**BUNCOMBE COUNTY
GENERAL SERVICES DEPARTMENT
40 McMORMICK PLACE
ASHEVILLE, NC 28801
(828) 250-4235**

BID DATE: Monday, November 20, 2023
DATE OF ADDENDUM: Thursday, December 14, 2023
ADDENDUM NUMBER: A

**SPORTS PARK - NEW RESTROOM BUILDING &
WATERLINE EXTENSION
BUNCOMBE COUNTY, NORTH CAROLINA**

2 UTILITY TRANSFORMER LOCATION AND HOT BOX WIRING DETAIL
E3 SCALE: NOT TO SCALE

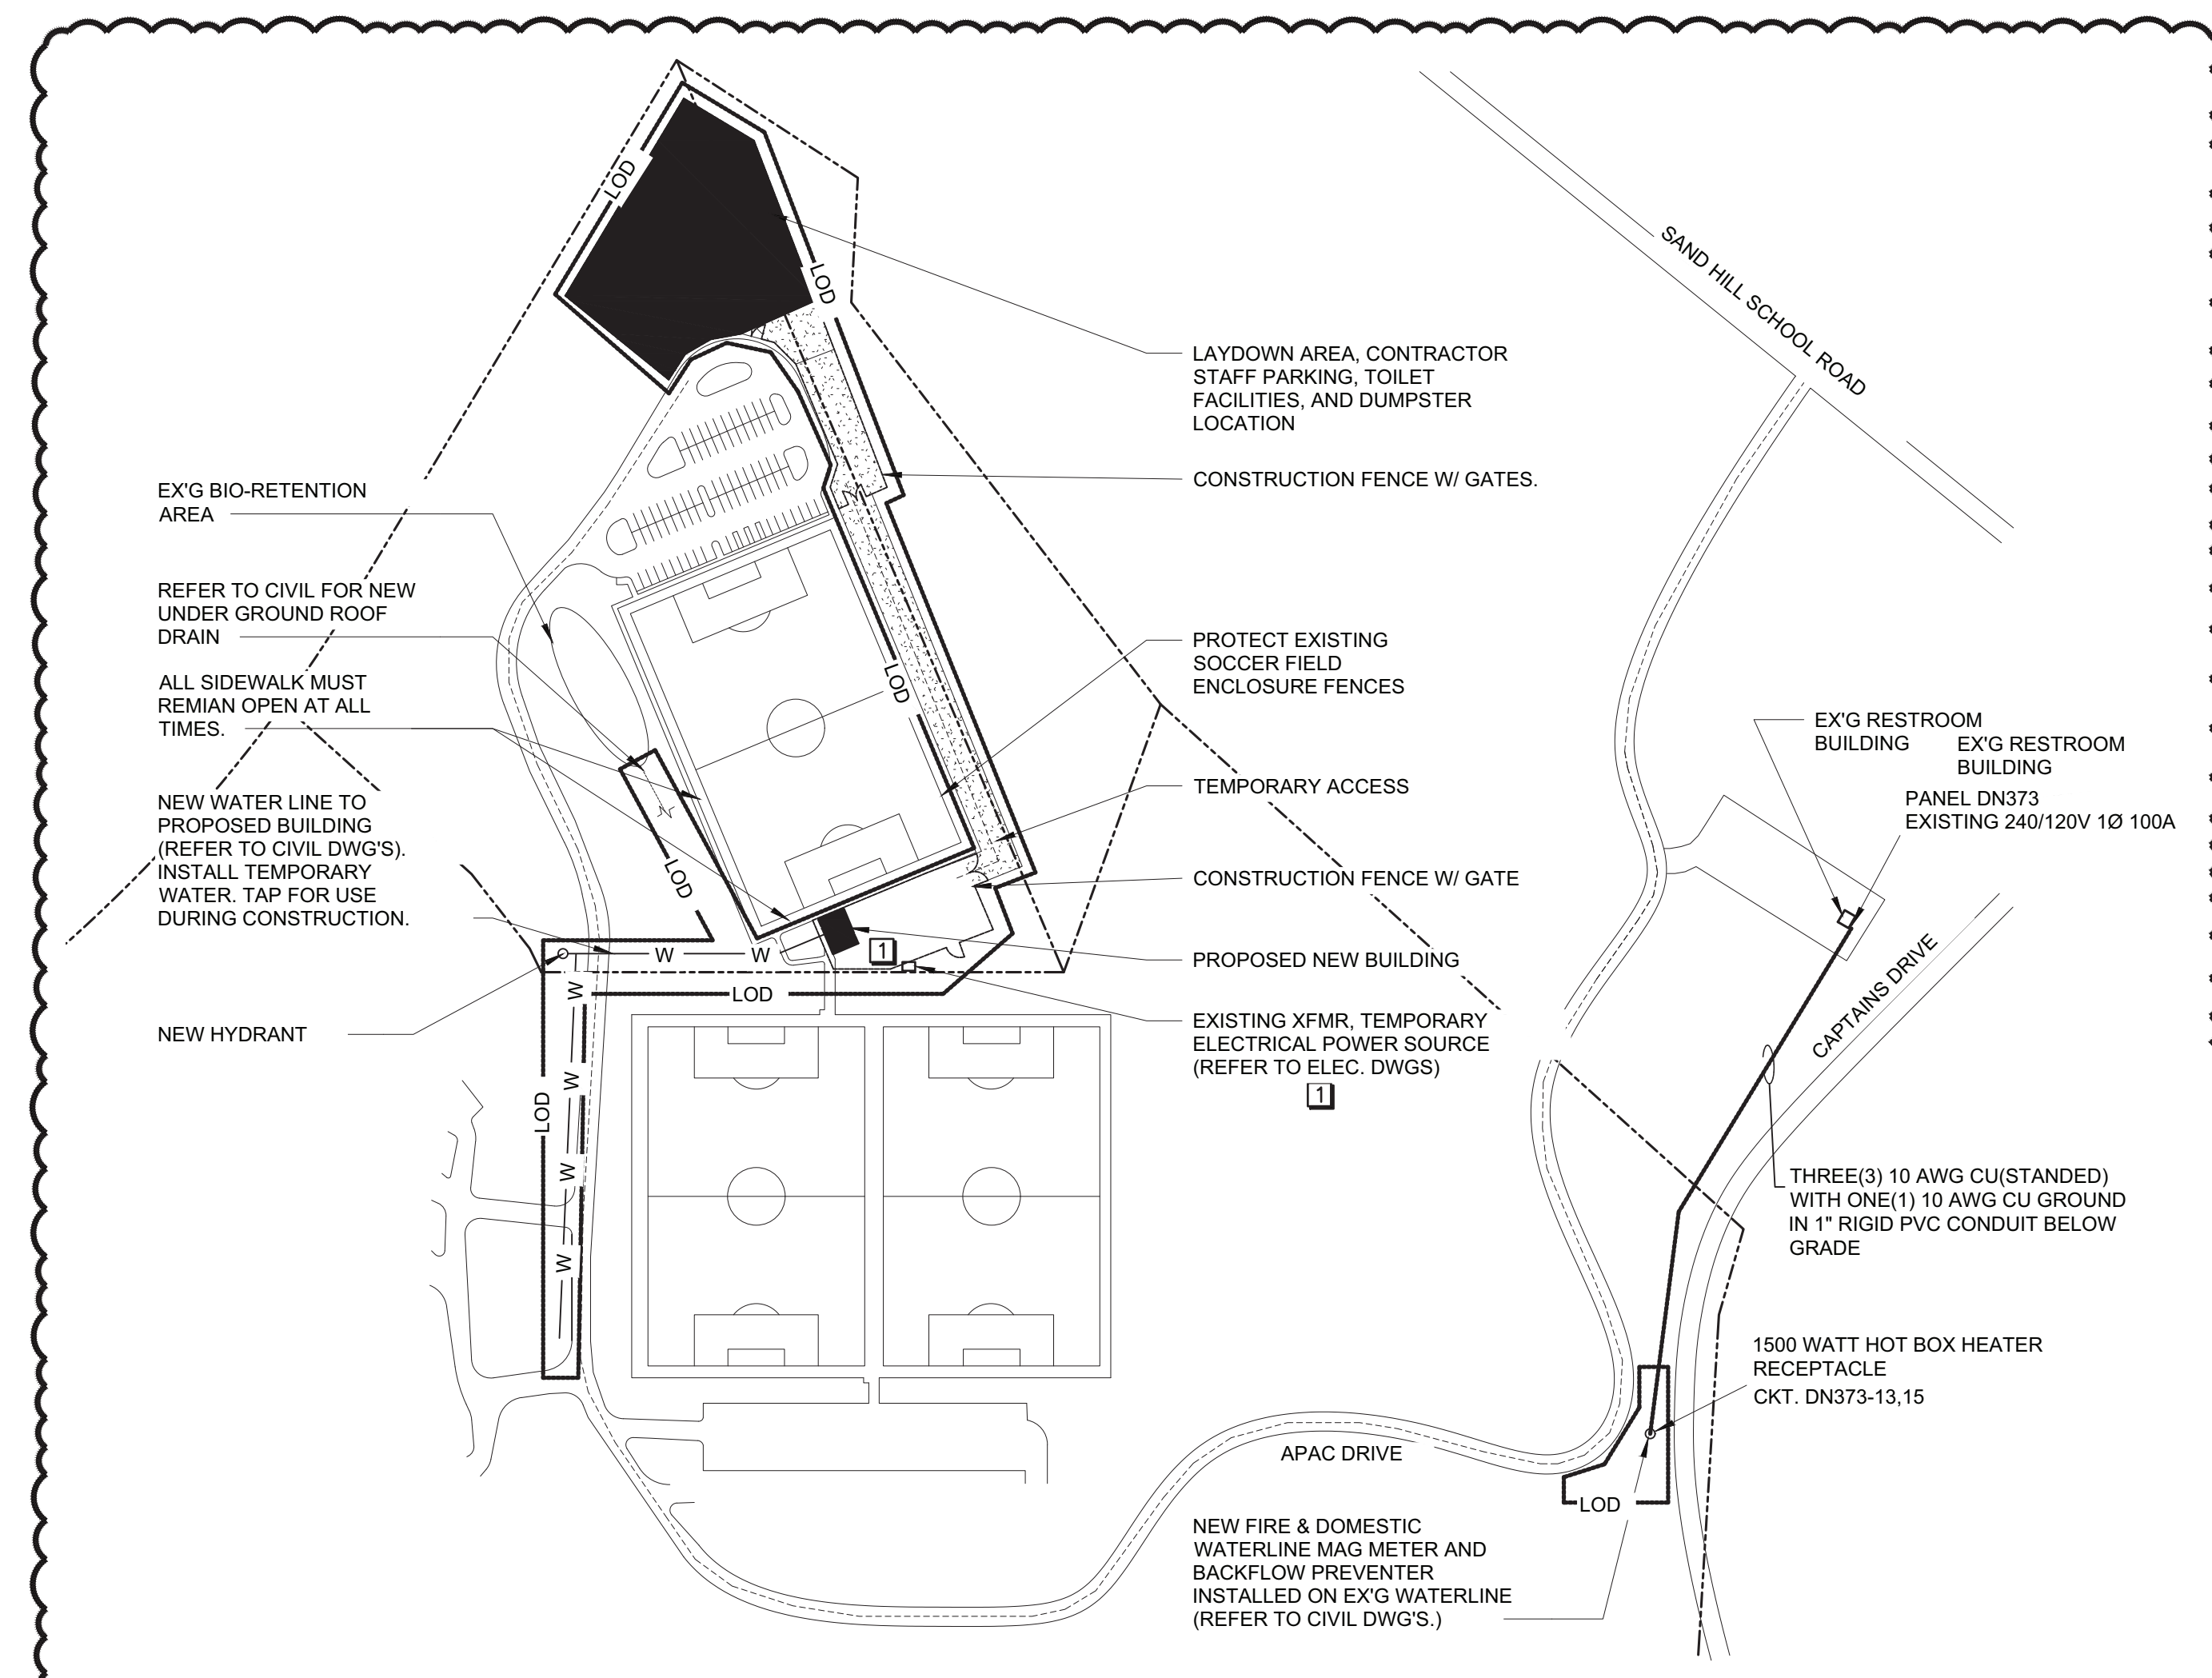
- Item 8 - Revised (A101). Ceiling Plan Legend revised to Finished Fiberglass Mat Faced Gypsum Board Ceiling in lieu of Cement Board Ceiling.
 - Item 9 - Revised (A103). Added door hardware sets. Updated Finish Legend and General notes.
 - Item 10 - Revised (P1). Site plan added for reference.
 - Item 11 - Revised (P2). Water pipe sizes clarified.
 - Item 12 - Revised (P3). Detail clarification.
 - Item 13 - Revised (M2). Modified a wall heater location and the inline exhaust fan location to avoid interference from the plumbing chair carriers.
 - Item 14 - Revised (E3). Added a site plan for reference and the existing panel schedule where the hot box heater is powered.
-
